**BOROUGH OF HIGHLANDS
LAND USE BOARD MEETING**
151 Navesink Ave. - Court Room
Thursday, May 09, 2024 at 7:00 PM

3. LUB2022-06: Martin, 15 Barberie Ave, B77 L15 - Extension Request
4. LUB2022-10: Home & Land - 14 & 32 North Peak, B35 Ls 8 & 9

**MINOR SUBDIVISION OF
LOTS 8, 9 ~ BLOCK 35**
32 & 14 North Peak Street
Borough of Highlands
Monmouth County, New Jersey

PROJ. No. 22-074
SCALE 1" = 100'
DATE 7/29/22
DRAWN BY MGB
TAX MAP SHEET # 10
SHEET 1 OF 3
DRAWING No. HL254

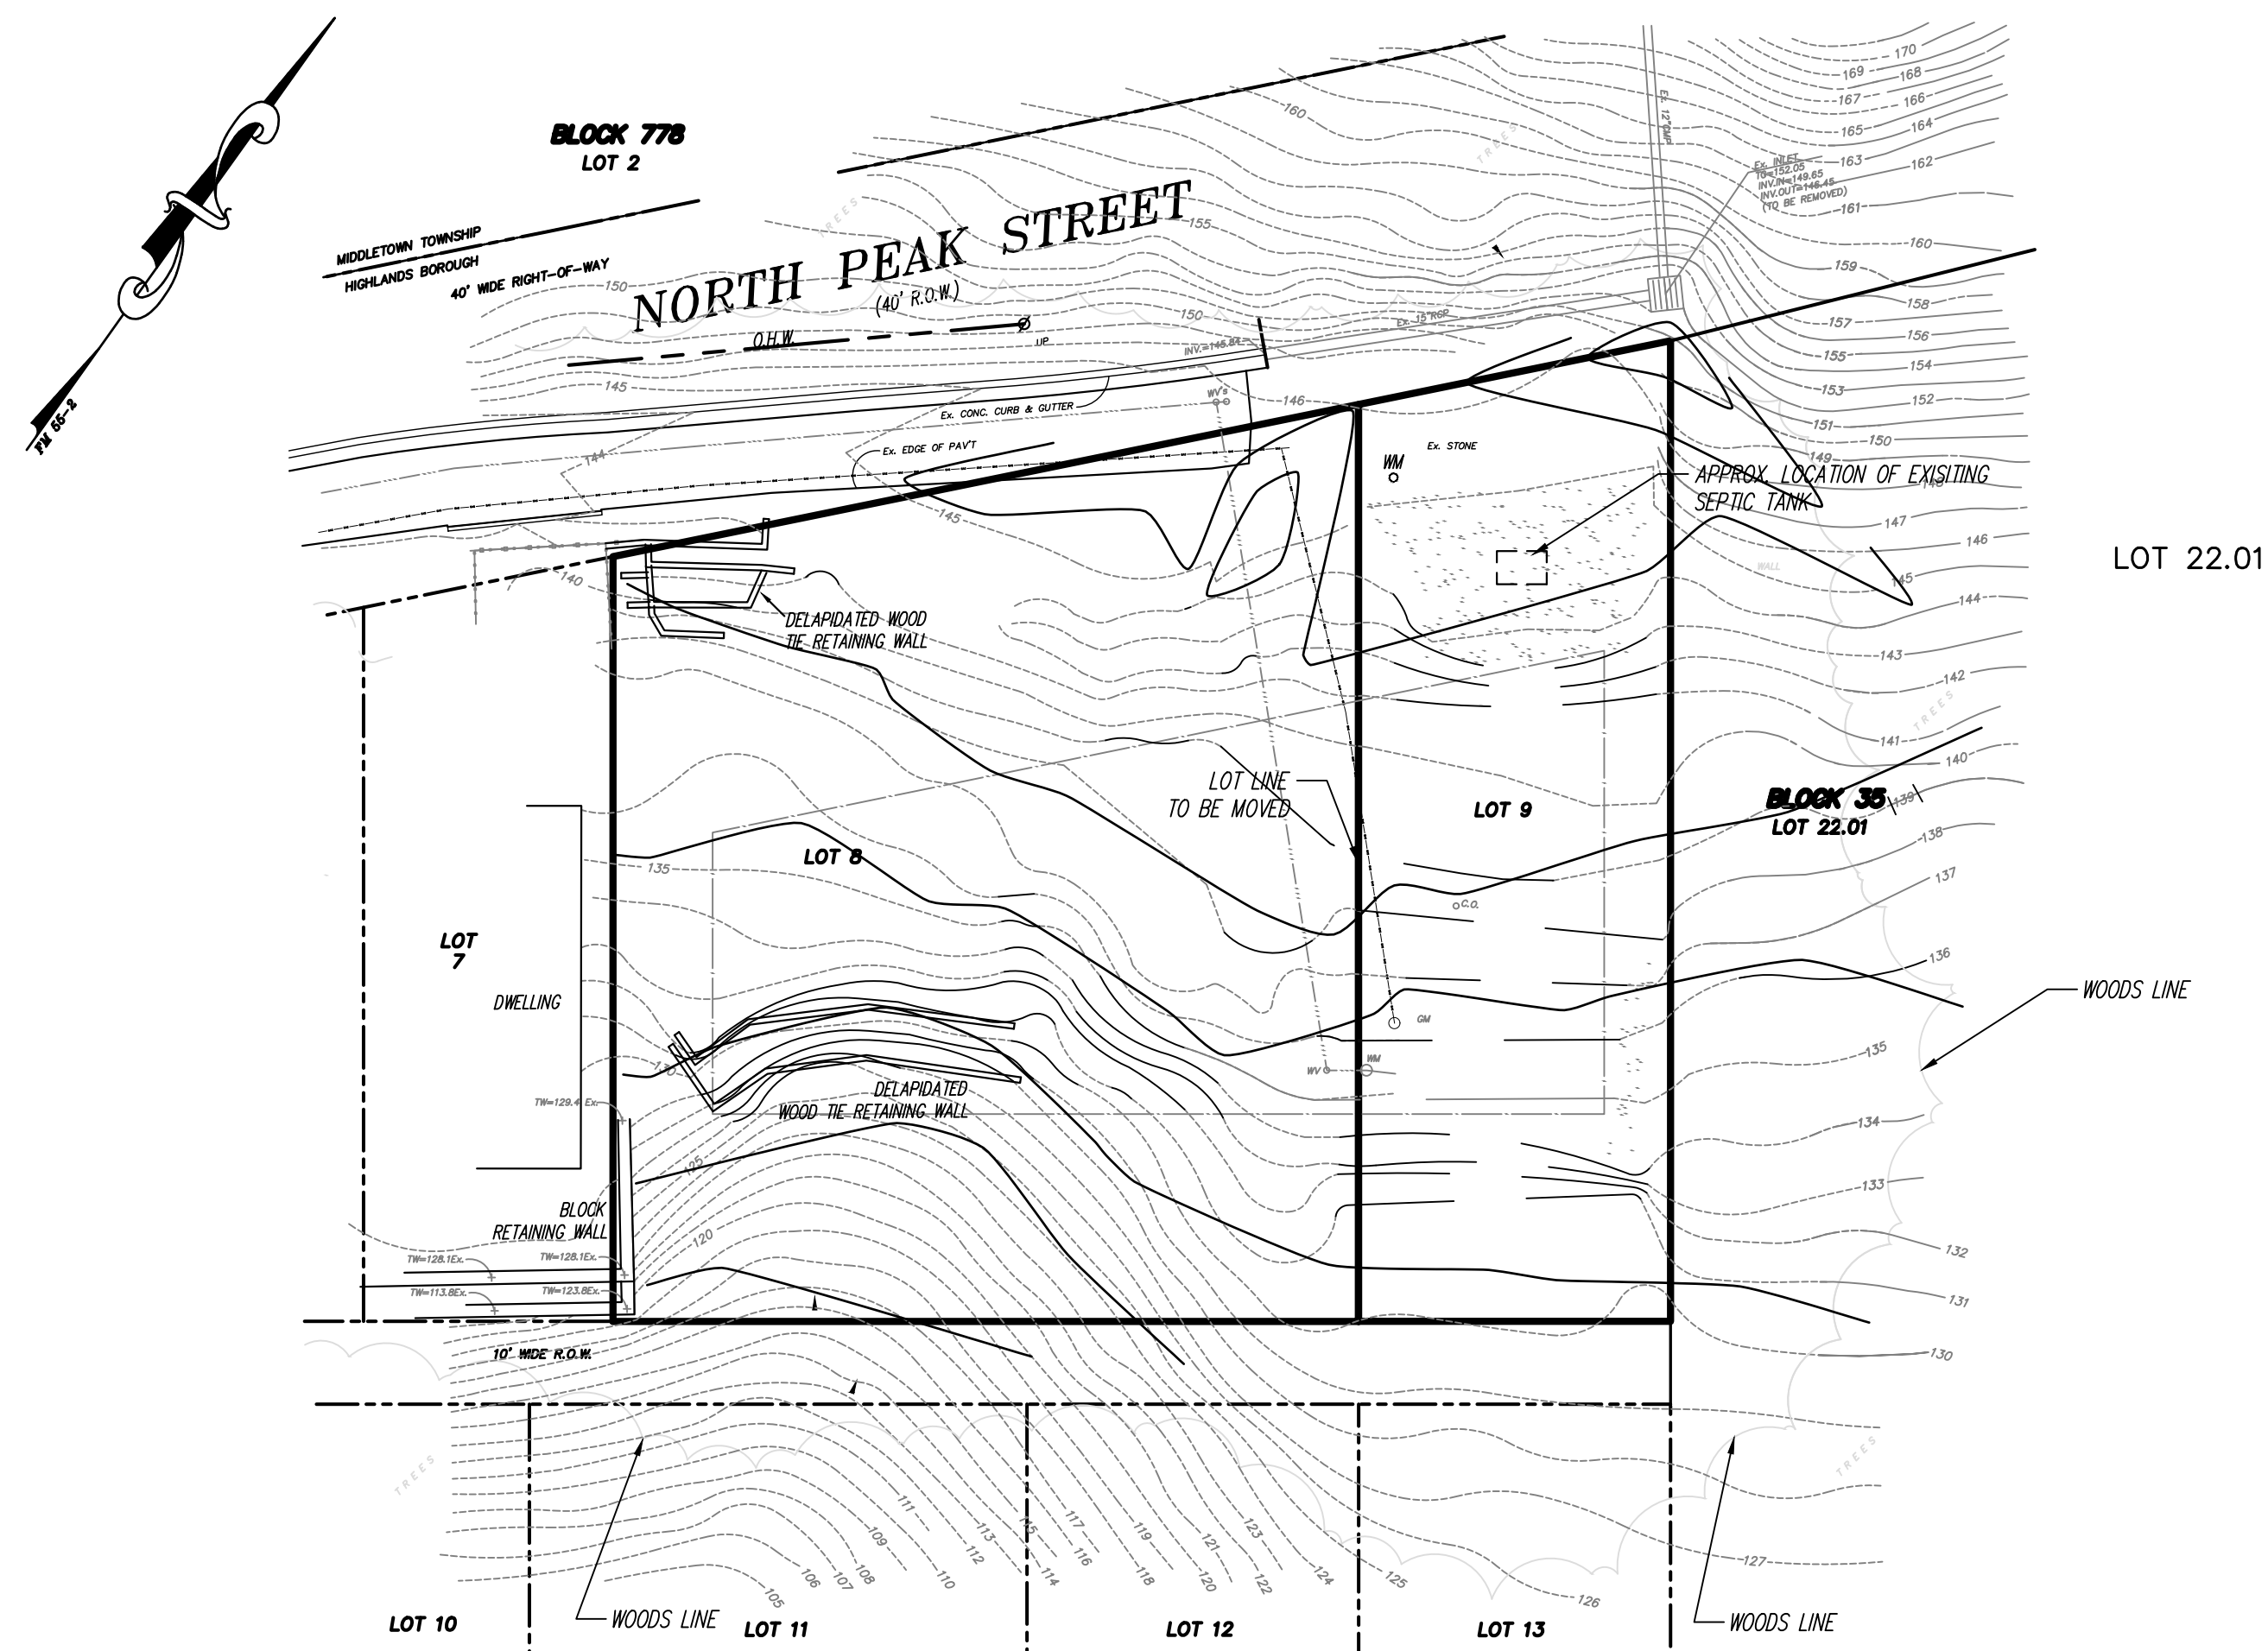
Provided on Sheet 1. Please add to the Minor Subdivision Plan.

PROJ. No. 22-074
SCALE 1" = 20'
DATE 7/29/22
DRAWN BY MGB
TAX MAP SHEET # 10
SHEET 2 OF 3
DRAWING No. HL254

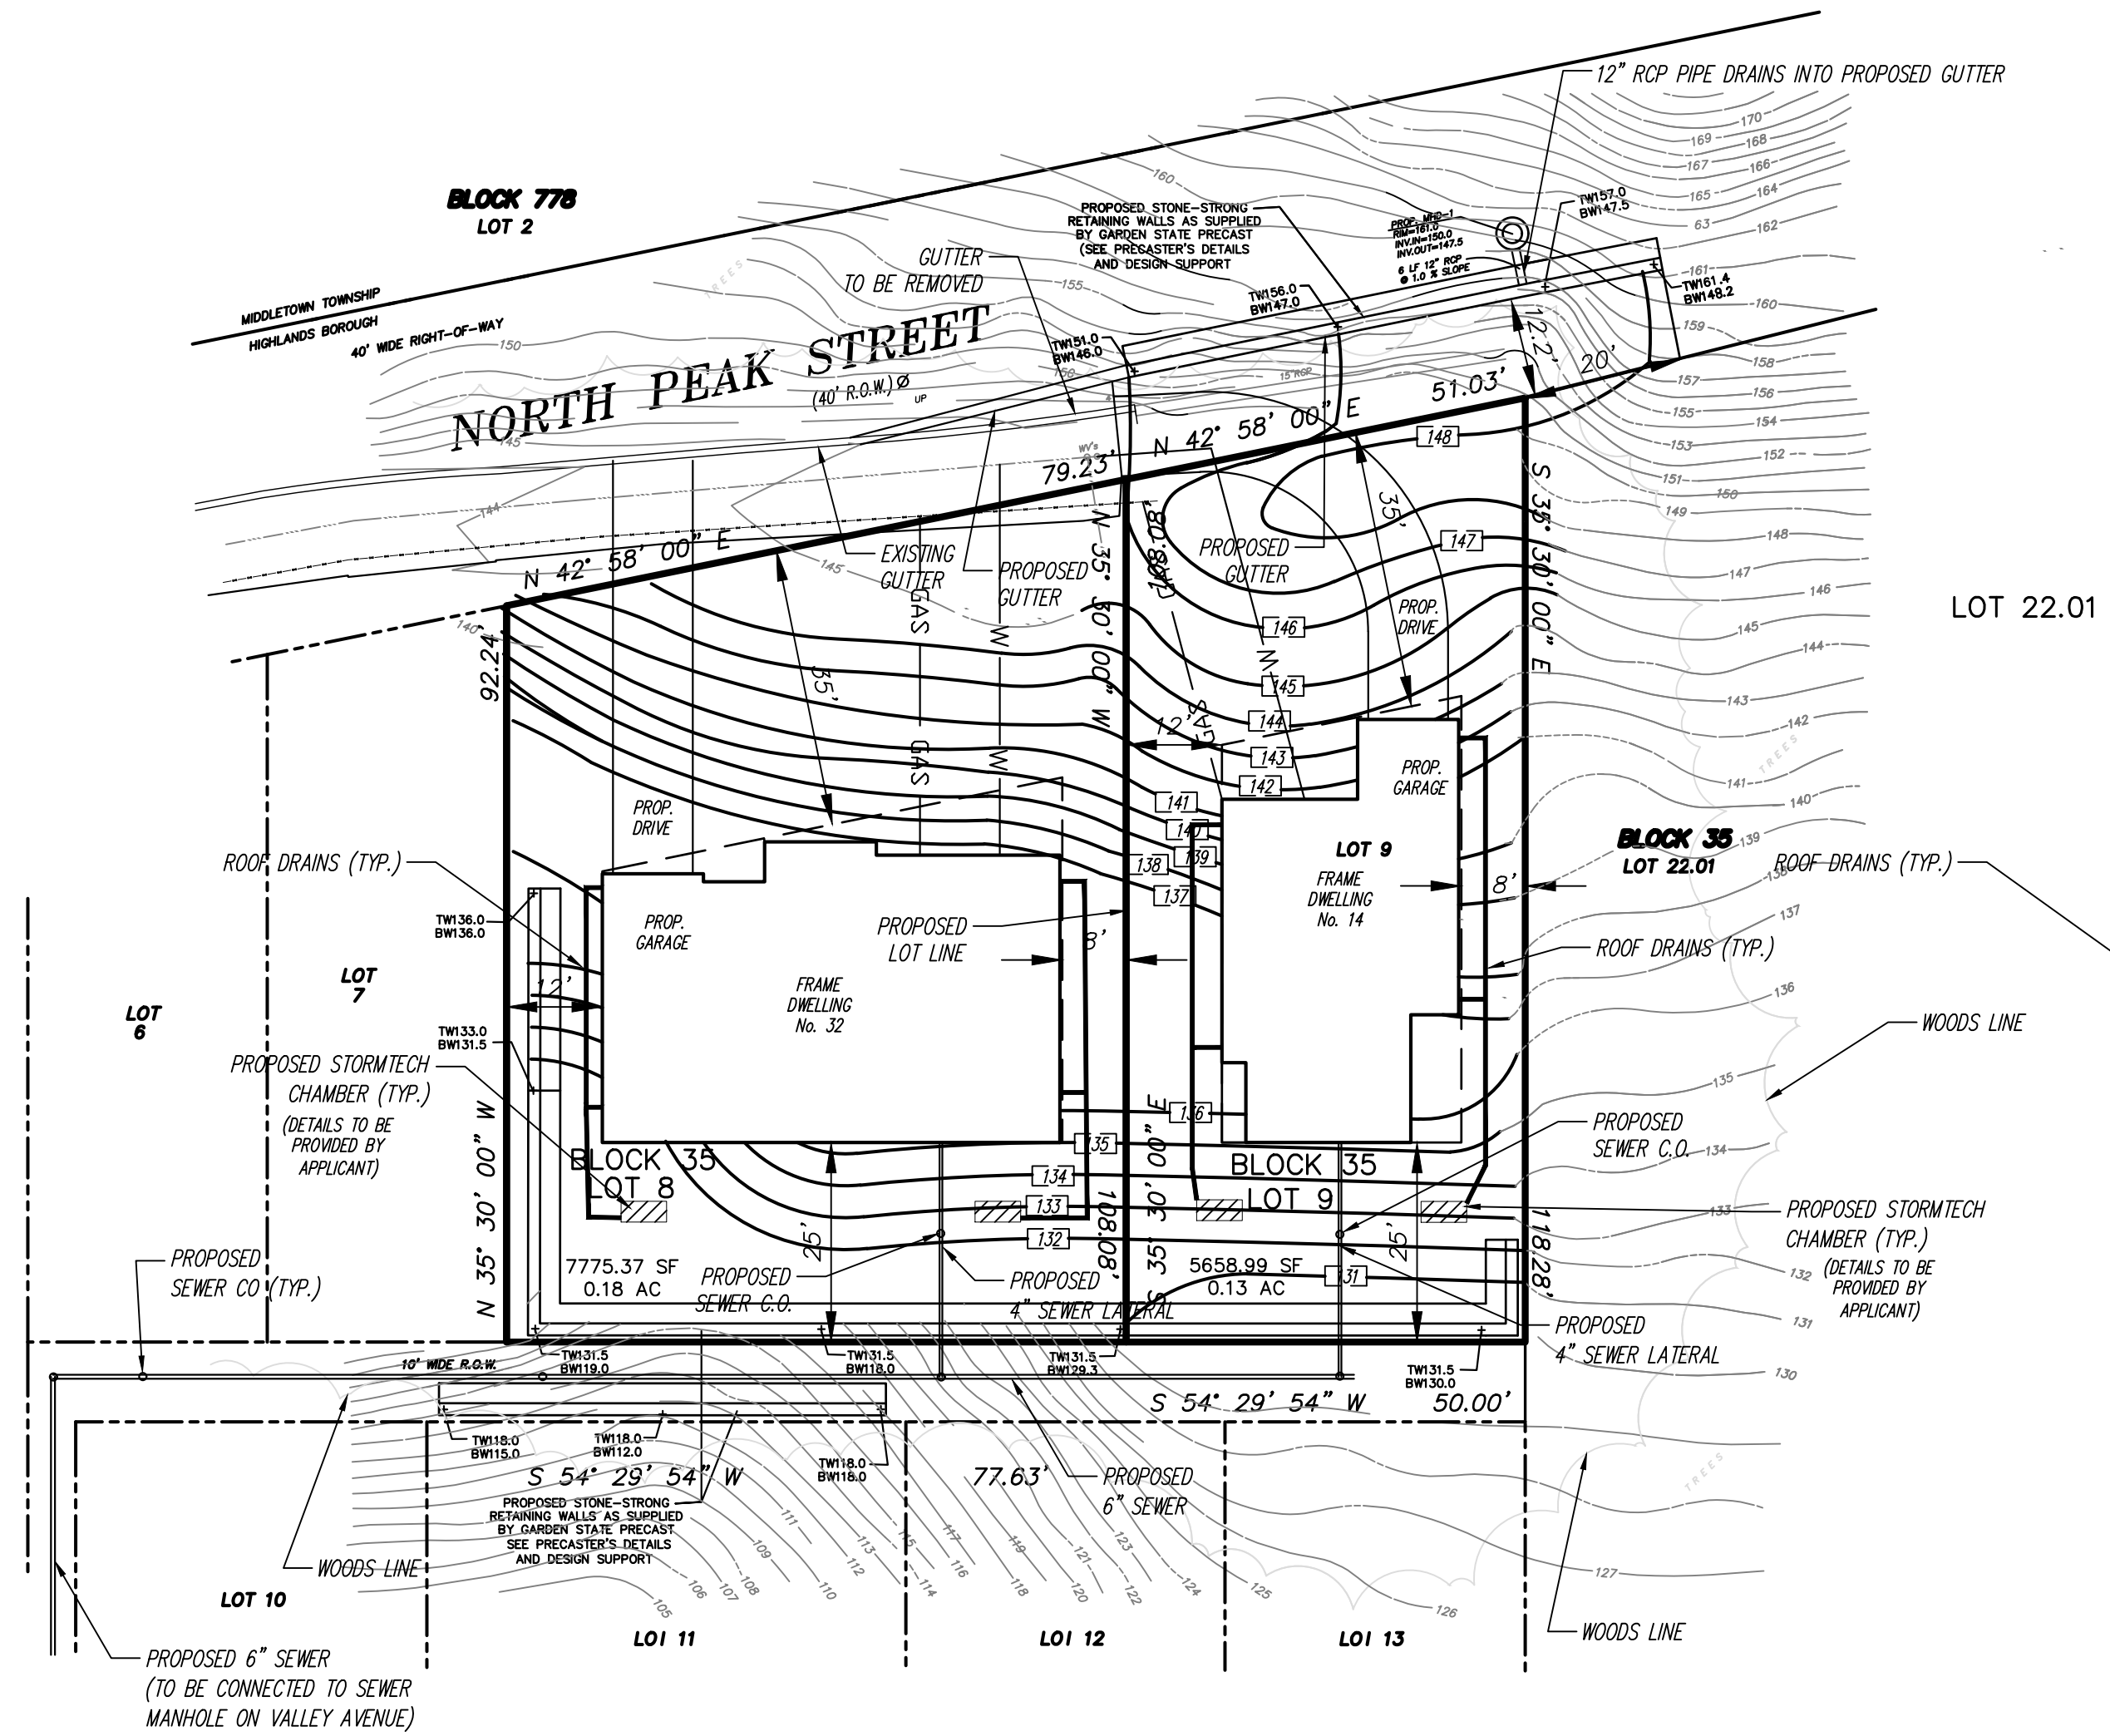
The current purpose of Sheet 2 is unclear and is not as complete as the previous submission.

Sheet 2 indicates the septic tank and one cleanout on existing Lot 9. The disposal bed and service lateral, as part of the system, is requested to be shown. Please provide documentation from the Health Department that the system has been or will be properly removed.

A profile of the lateral connection from the proposed dwelling to the manhole connection on Valley Avenue has been provided on sheet 4 of 8. Monmouth county 2' contours were used for areas not within the surveyed information.
